**OPEN SPACE ADVISORY BOARD**  
Wednesday, February 2, 2011, 1:30 P.M.  
8<sup>th</sup> Floor Conference Room  
City Hall Building, 2 Civic Center Plaza

**Case No:** ZON10-00116  
**Application Type:** Detailed Site Development Plan  
**CPC Hearing Date:** February 10, 2011  
**Staff Planner:** Arturo Rubio, 915-541-4633, [rubioax@elpasotexas.gov](mailto:rubioax@elpasotexas.gov)

<b>Case No.</b>	ZON10-00112
<b>Application Type</b>	Detailed Site Development Plan Review
<b>OSAB Meeting Date</b>	February 2, 2011
<b>Staff Planner</b>	Esther Guerrero, 915-541-4720, <a href="mailto:guerreroex@elpasotexas.gov">guerreroex@elpasotexas.gov</a>
<b>Location</b>	810 Redd Road
<b>Legal Description</b>	Portion of Lot 27, Block 123, Chaparral Park Unit 33, City of El Paso, El Paso County, Texas
<b>Acreage</b>	1.477 acres
<b>Rep District</b>	1
<b>Existing Use</b>	Vacant
<b>Existing Zoning</b>	C-1/c (Commercial/condition)
<b>Request</b>	Detailed Site Plan Review required per Ordinance No. 017250
<b>Property Owner</b>	Gary Porras
<b>Applicant</b>	Same
<b>Representative</b>	Carrera Group Inc.

**Case No:** SUB11-00017 Paseo Del Norte Blvd Unit 2  
**Application Type:** Major Preliminary  
**CPC Heari

01 SITE PLAN  
SCALE: 1" = 60'

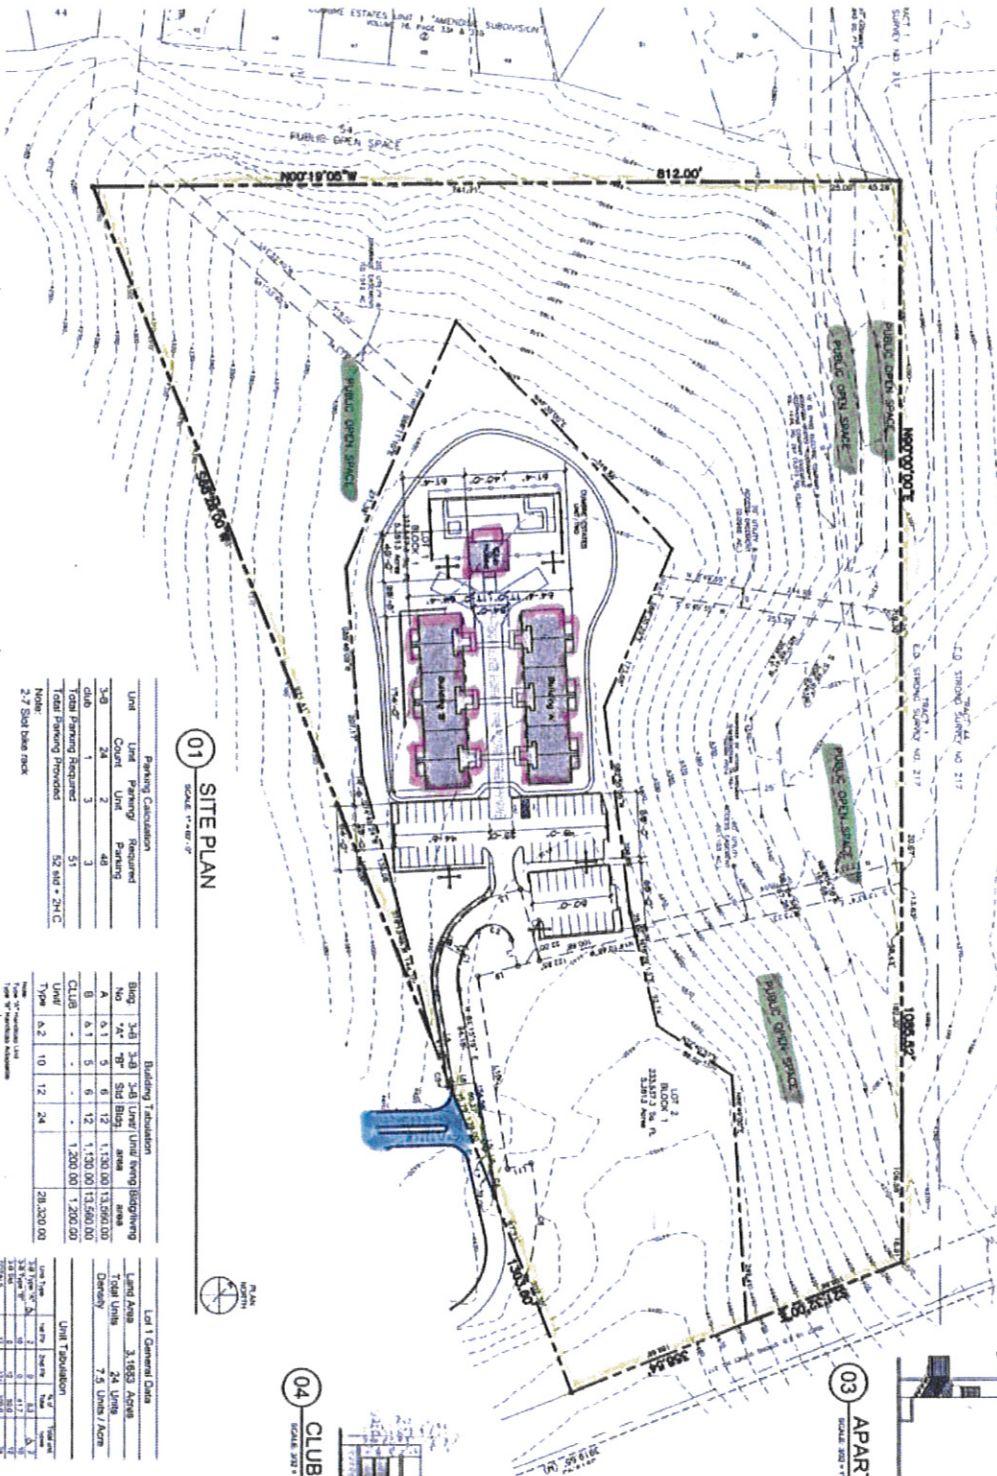
1. Provide existing & proposed drainage flow on site plan.
2. ADA accessible Sidewalks, Wheel-chair ramp(s), and Driveway(s) will be required.\*
3. Grading plan and permit shall be required.\*
4. Storm Water Pollution Prevention Plan and/or permit required.\*
5. Drainage plans must be approved by Engineering and Construction Management Department, Land Development Section.\*
6. The Subdivision is within Flood Zone C, "Areas of minimal flooding"- Panel # 480214 0028C, date February 5, 1986.

1. Recommend that the site plan be processed simultaneously with the proposed subdivisions to ensure proper access.
2. All existing / proposed paths of travel, accessible sidewalks, wheel chair access curb ramps and driveways within public right-of-ways shall be in compliance with current ADA /TAS rules and regulations and Current City of El Paso Design Standards for Construction.
3. Recommend pedestrian path or markings to offer safe route to apartment from outer parking spots.

1. EPWU-PSB cannot confirm the availability of sewer service to a portion of the site plan at this time (proposed Lot 2, Block 1, Cumbre Estates 2).
2. The original sanitary sewer facility plans for the entire Cumbre Estates Subdivision were designed by an Engineering firm (the Engineer) retained by the Owner/Developer, and not by the El Paso Water Utilities – Public Service Board (EPWU-PSB). EPWU-PSB requires the Owner/Developer to have his Engineer certify in writing (signed and sealed by Professional Engineer) that the design of the existing low pressure

sanitary sewer system possesses the capacity to provide service to the additional lots proposed on Cumbre Estates Unit 1 Replat B and the proposed Lot 2, Block 1 within Cumbre Estates Unit 2 before EPWU allows sewer service for Lot 2 from the low pressure system.

# ATTACHMENT 3: DETAILED SITE DEVELOPMENT PLAN

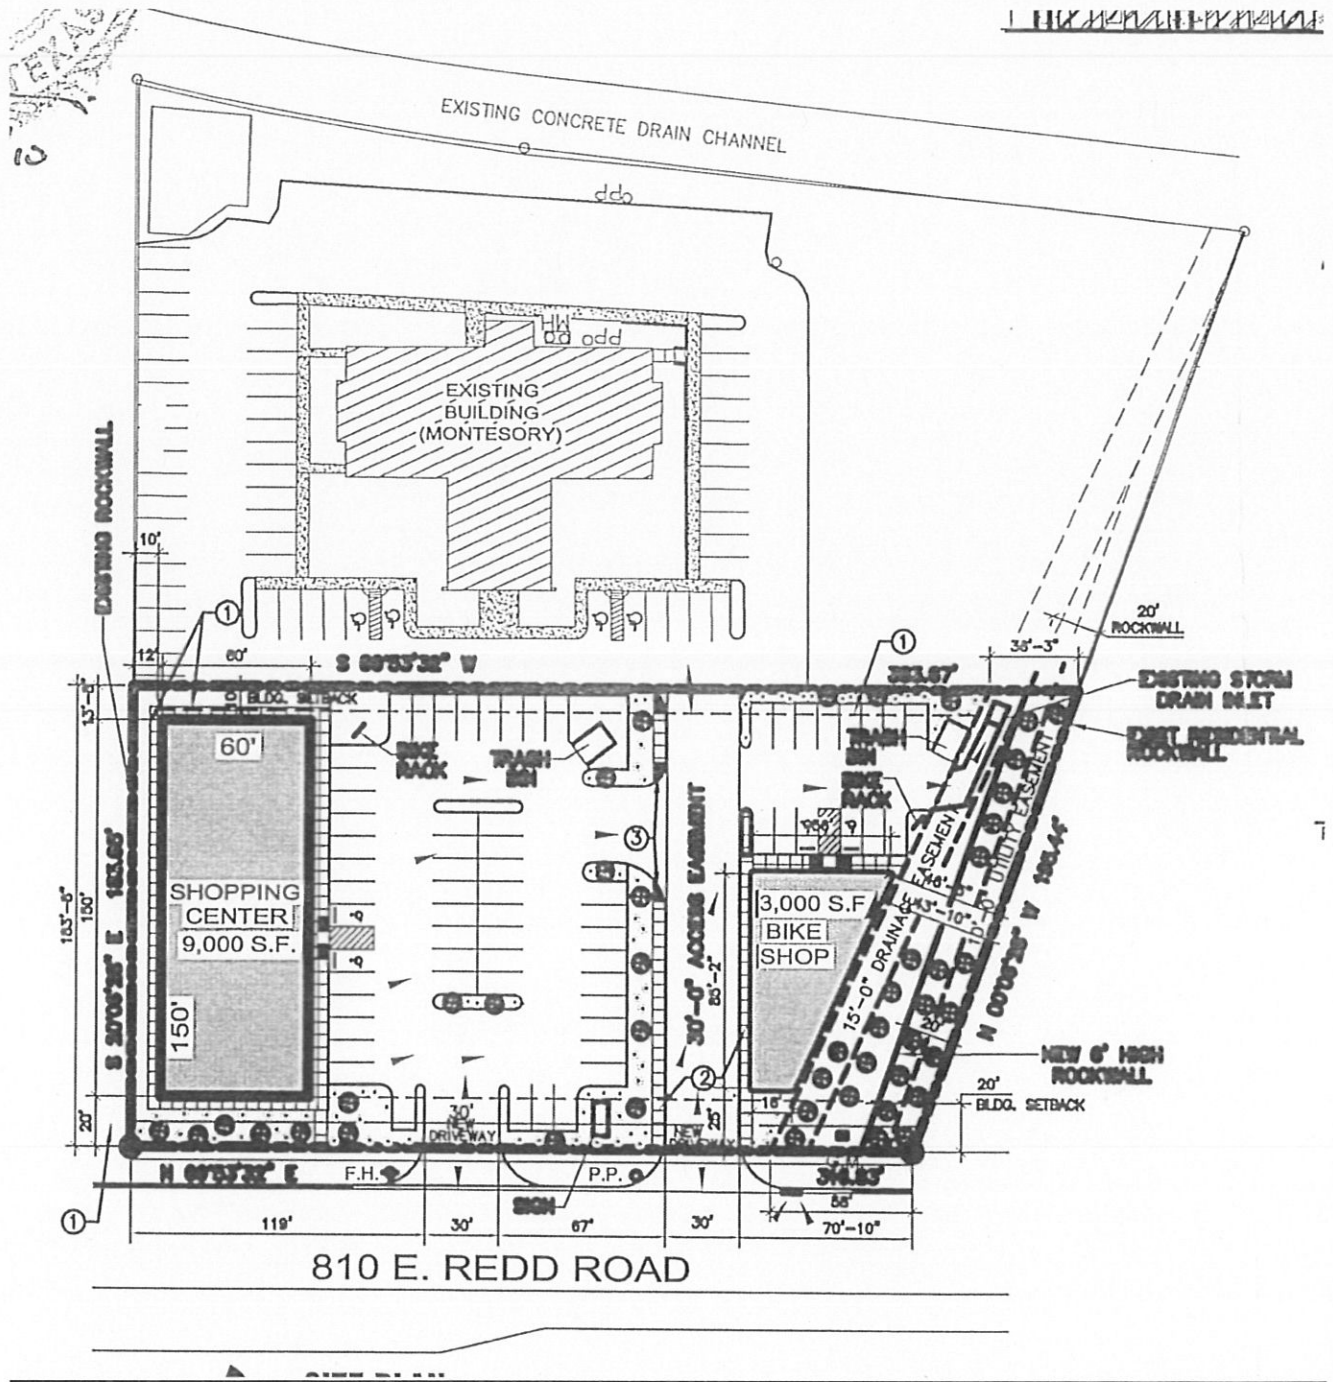
- All existing / proposed paths of travel, accessible sidewalks, wheel chair access curb ramps and driveways within public right-of-ways shall be in compliance with current ADA /TAS rules and regulations and Current City of El Paso Design Standards for Construction.
- Parking stall and aisle dimensions need to be included on plan.
- Internal driveway widths are missing on plan.
- Wheel stops needed for parking spaces adjacent to pedestrian walking area and city ROW.

1. ADA accessible Sidewalks, Wheel-chair ramp(s), and Driveway(s) will be required.\*
2. Grading plan and permit shall be required.\*
3. Storm Water Pollution Prevention Plan and/or permit required.\*
4. Drainage plans must be approved by Engineering and Construction Management Department, Land Development Section.\*
7. The Subdivision is within Flood Zone C, "Areas of minimal flooding"- Panel # 480214 0022EC, date January 3, 1997.
